## CERTIFICATE OF APPROPRIATENESS

**Property:** 1604 North Boulevard, Lot 8, Block 2, Edgemont Subdivision. The property includes a historic Mediterranean style residence, with 8,661 square foot of living space and is situated on a 15,000 square foot interior lot.

**Proposal:** Alteration – Addition

HPO File No. 160429

## SOUTH ELEVATION – FRONT FACING NORTH BOULEVARD

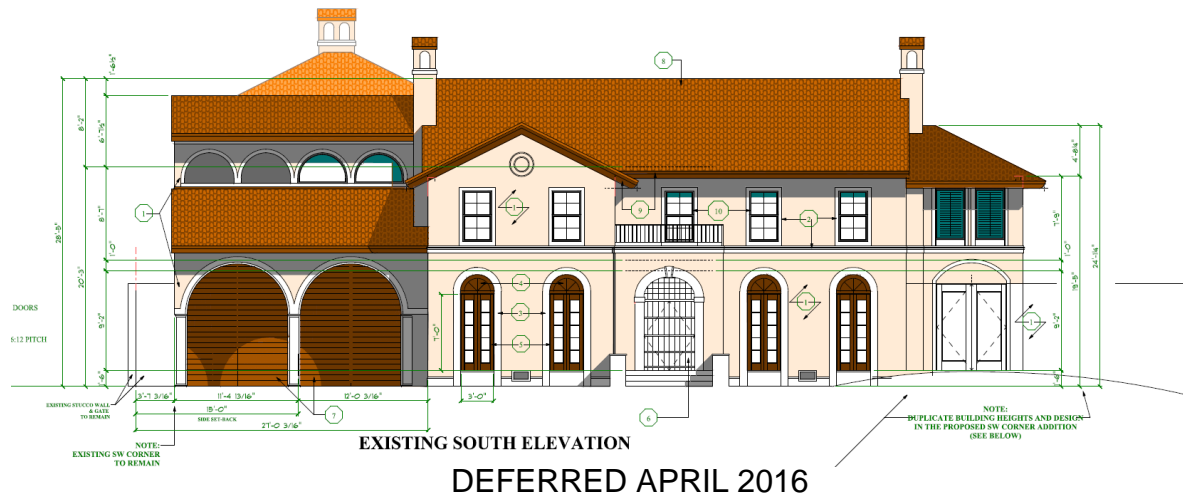
**Front Elevation:** Garage doors will be changed and transom windows will be added above the garage doors.  
**(South)** Windows that flank main entrance will be replaced with more historically correct windows. Please refer to elevation drawings for more details. The southwest corner of the house will be restructured to match southeast corner.

4. What appears to be a “dormer” in the front elevation drawing is actually the front prow of a new north-south roofline that is to be topped with the protruding skylights. There is nothing like that in all of the Boulevard Oaks Historic District, and nothing like that should be allowed unless it can be demonstrated that it would not be visible from outside the property.

**Front elevation** - we approve either version 4 or 5 of the front elevation subject to the exceptions noted above. As a note of explanation, the structure over the front door in option 3, although matching the pitch of the existing gable-end roof, is more of a tower since it has a common wall surface with the second floor wall below. We believe a dormer (as proposed in the other options) is inconsistent with the prevailing architecture in the neighborhood.

# NORTH (REAR) ELEVATION

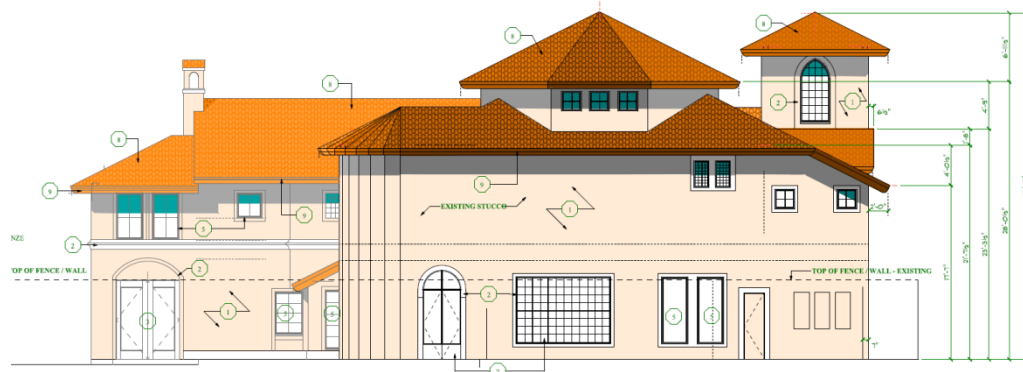
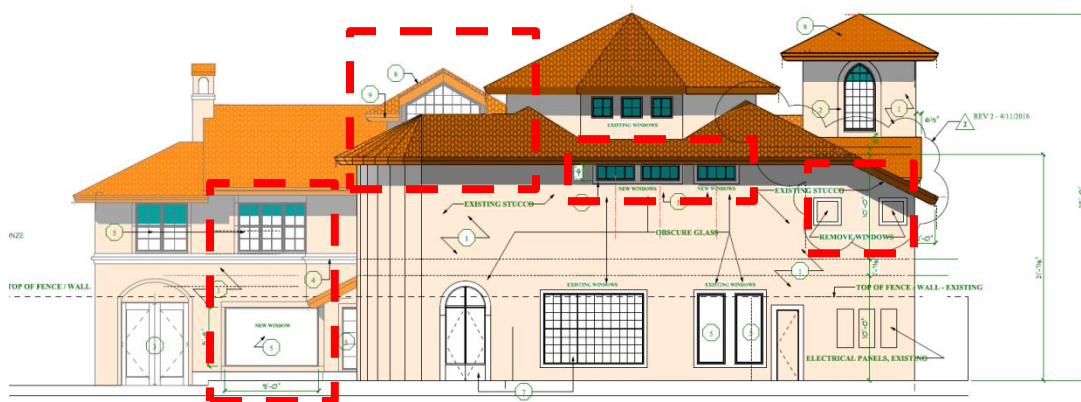
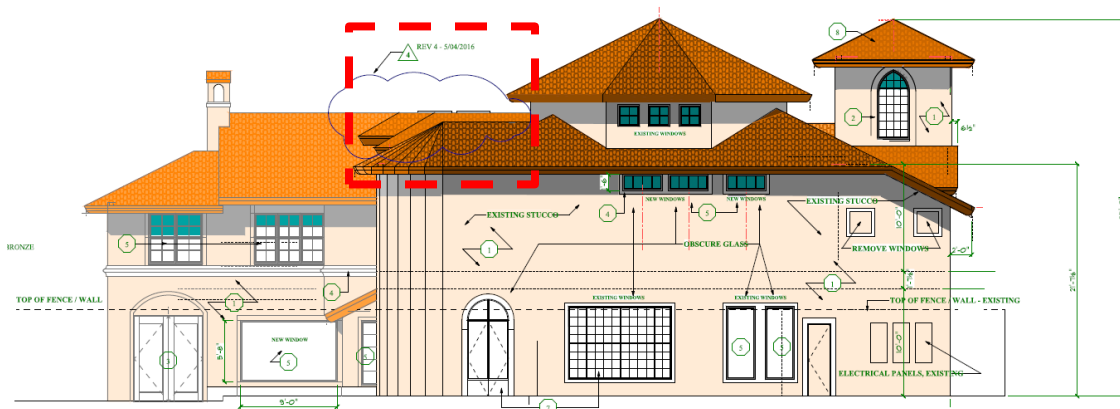
**Rear Elevation:** In the east bay, one window opening on the first and second floor will have size and opening  
**(North)** change. In the center bay two window openings will be closed and three new windows will be  
installed. Two windows will be closed up in the west bay. Please refer to elevation drawings for  
more details.

EAST ELEVATION

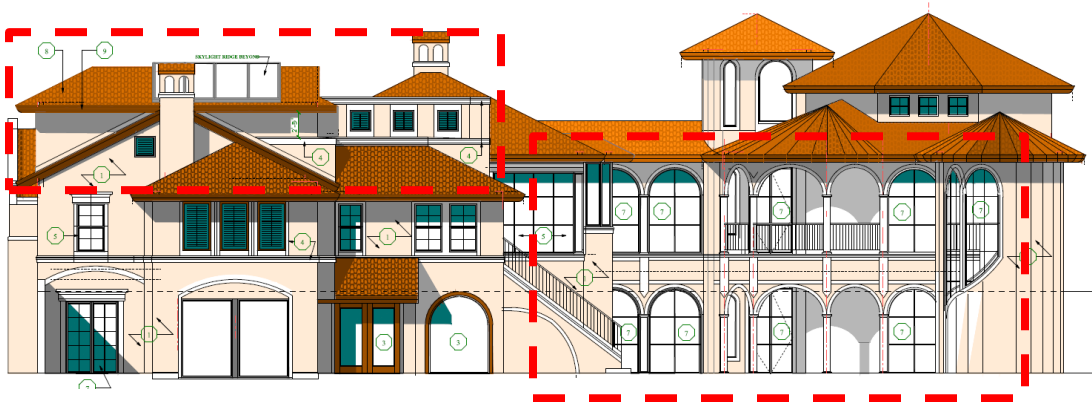
**Side Elevation:** Door opening on first floor in west bay will be opened for larger door. In the center bay arched  
**(East)** window opening will become a large casement window. Multiple archways will be enclosed,  
converted into windows. Please refer to elevation drawings for more details.

## WEST SIDE ELEVATION

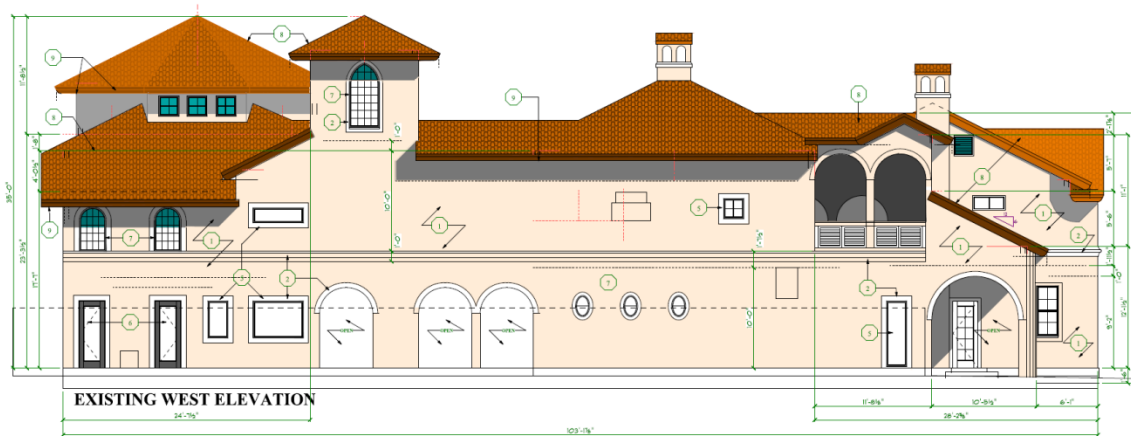
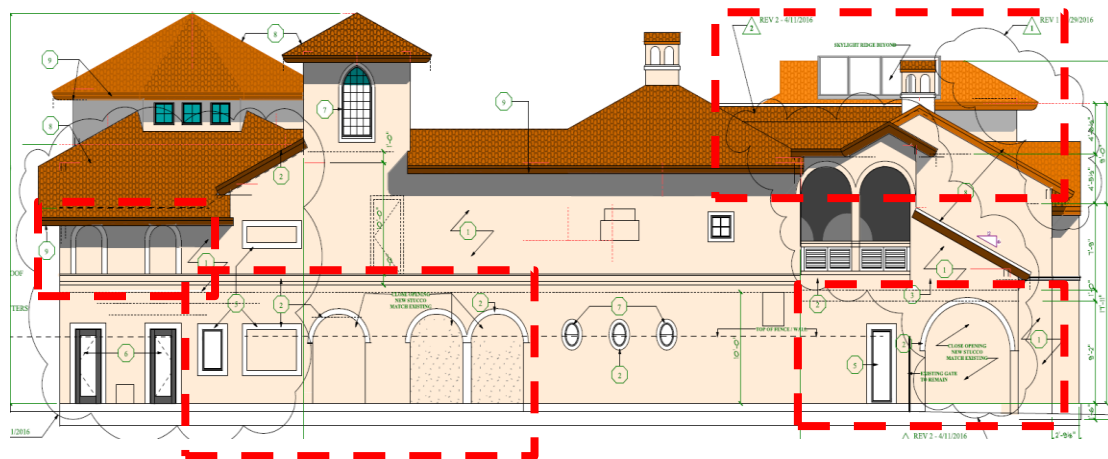
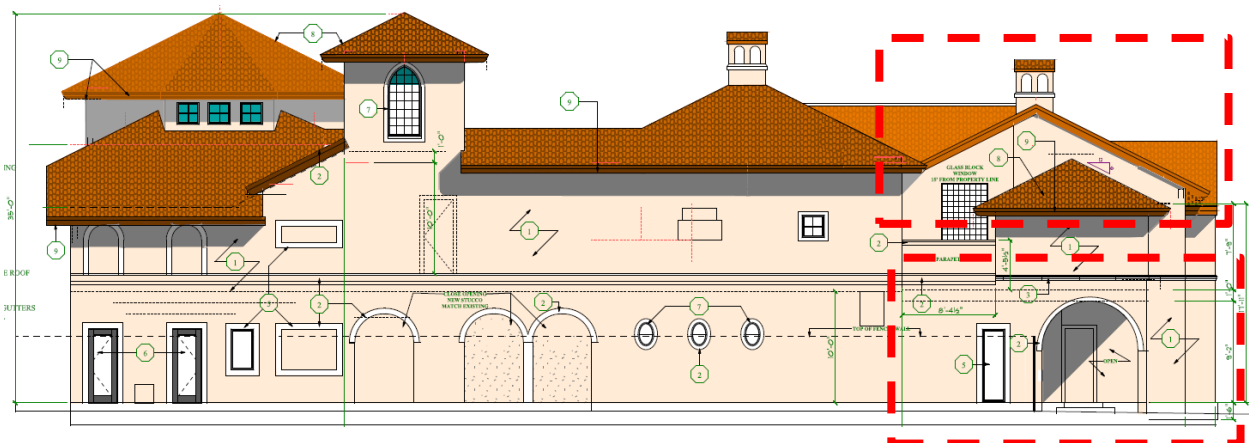
**Side Elevation:** Closure of seven window openings on first and second floor in the north bay. Closure of two  
**(West)** window openings in the south bay. Archway in south bay will be closed for new proposed garage.  
Please refer to elevation drawings for more details.

2. The structures at 1604 North Boulevard are already massively invasive of the side property line setbacks prevailing throughout the Boulevard Oaks Historic District, to the substantial detriment of the property owners to the immediate west of 1604 North Boulevard. I object to the huge and virtually unrelieved wall that is now proposed for the west façade of these invasive structures.

**Covering openings on the West side of home** – ok, with the exception of the west side of the porte-cochere, which is not approved

## ROOF PLAN

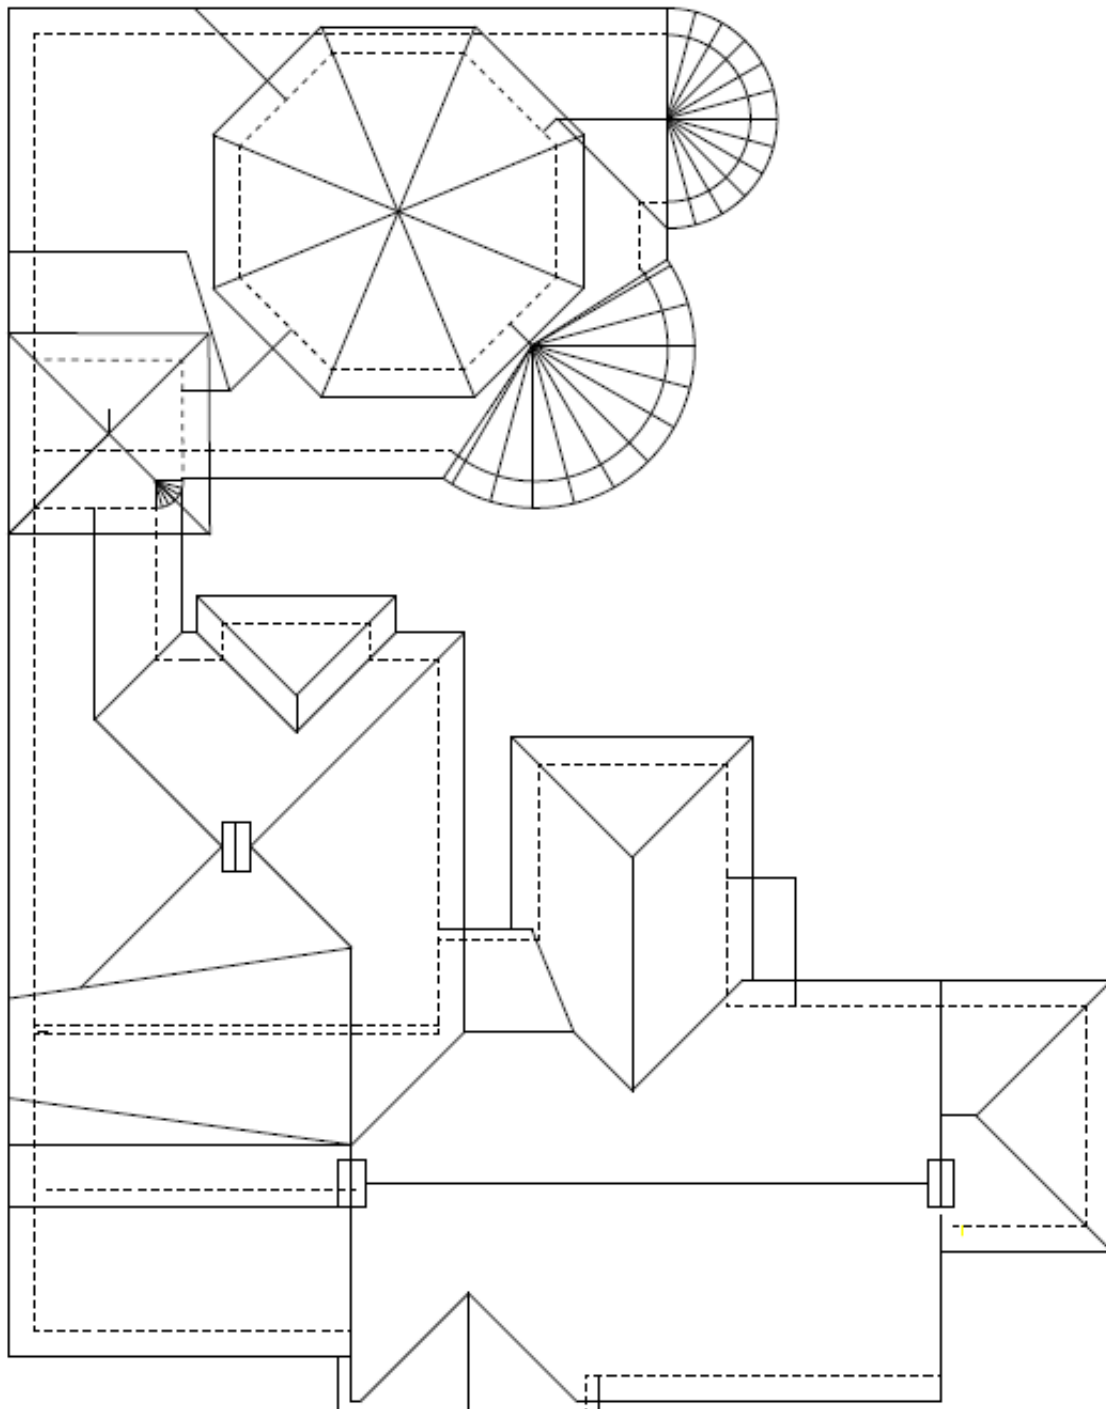
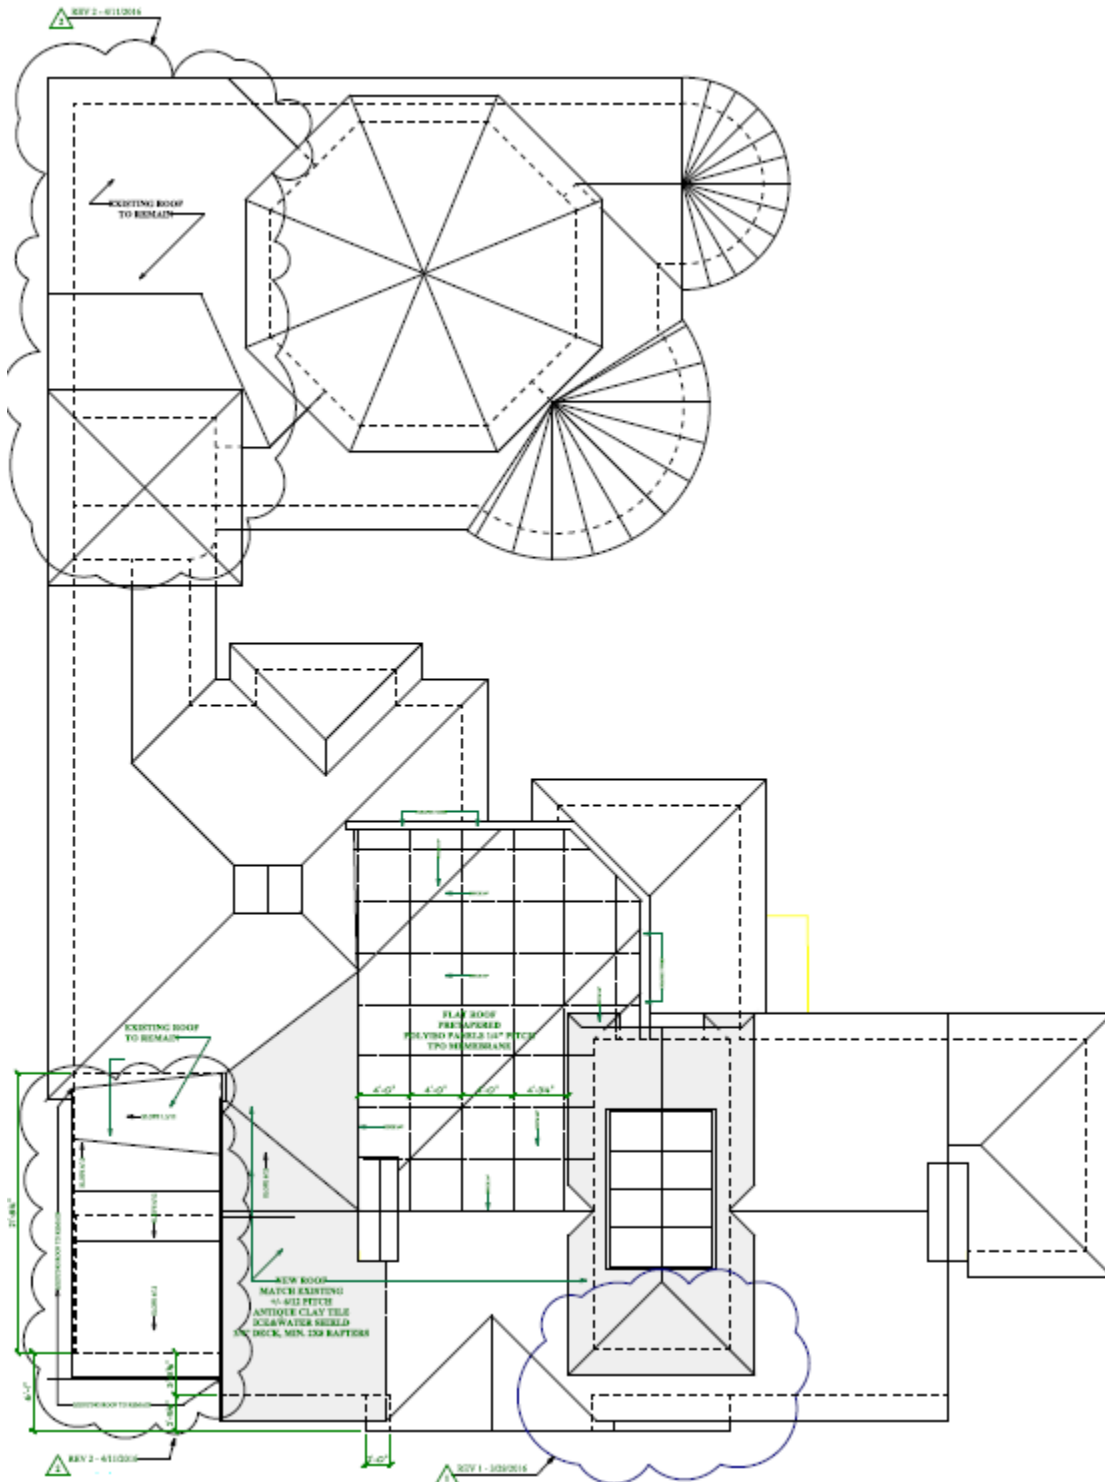
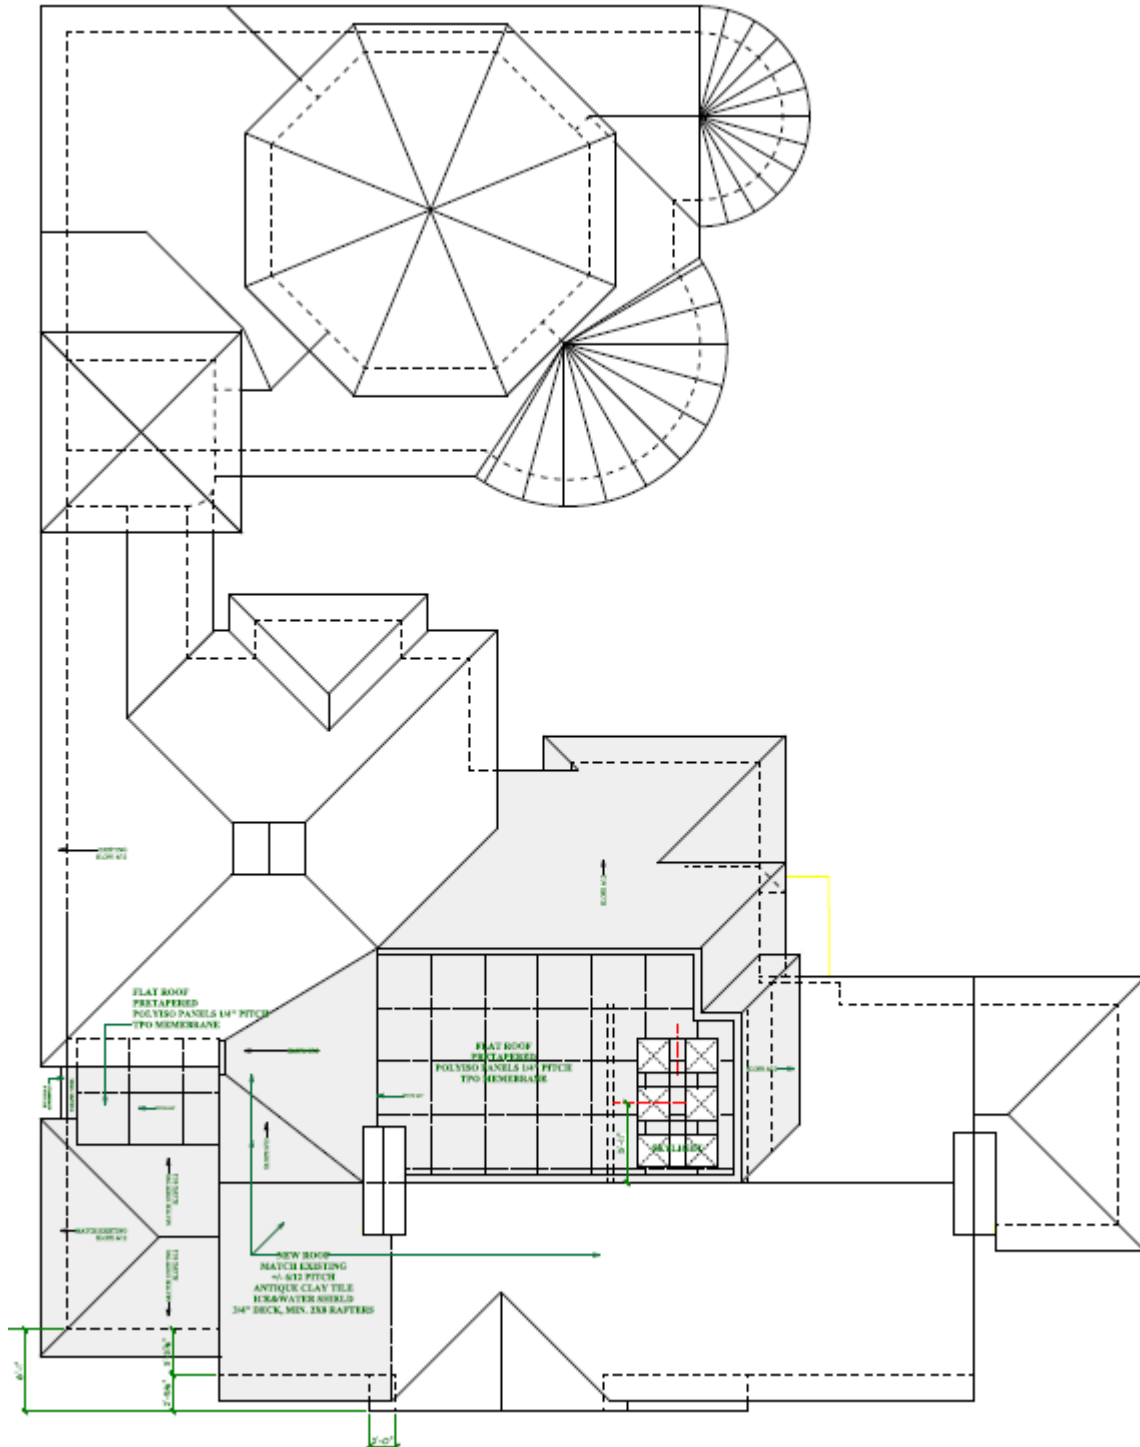
- The addition of a dormer skylight on the front of the residence bumps the ridge height up to 32'-3 3/8". The skylight features a hipped roof on the front and a gable at the rear.
- The proposed addition above carport and in front of garage has a side gable roof with a new ridge height that will match existing at 28'-5" and a new eave height of 17'-11".
- A flat roof located behind the existing ridge and between new garage and skylight additions will match the height of 28'-5" of house.

- The proposed addition above carport and in front of garage has a side gable roof with a new ridge height that will match existing at 28'-5" and a new eave height of 17'-11".
- The restructured southwest corner will have a hipped roof and will match with southeast corner and have a new ridge height of 24'- 1 1/4" and new eave height of 19'-5".
- A flat roof located behind the existing ridge and between new garage and skylight additions will match the ridge height of 28'-5".

3. I believe that the new plans likely violate the objective height limits imposed by the Edgemont deed restrictions. Not shown the front elevation drawing that was submitted to establish height compliance by reference to an apparent “dormer” in that drawing, are the skylights that are shown, in another drawing, to obtrude above the peak of the apparent “dormer”. The Architectural Committee advised the 1604 North Boulevard property owner’s architect of this concern about height violation when it responded to the second set of plans, but the third set of plans did not address this concern and there has been no other response to that question.

**Skylight** - ok as described to the Architectural Committee, conditioned on the requirement that it will not be visible from the street or adjacent residences.
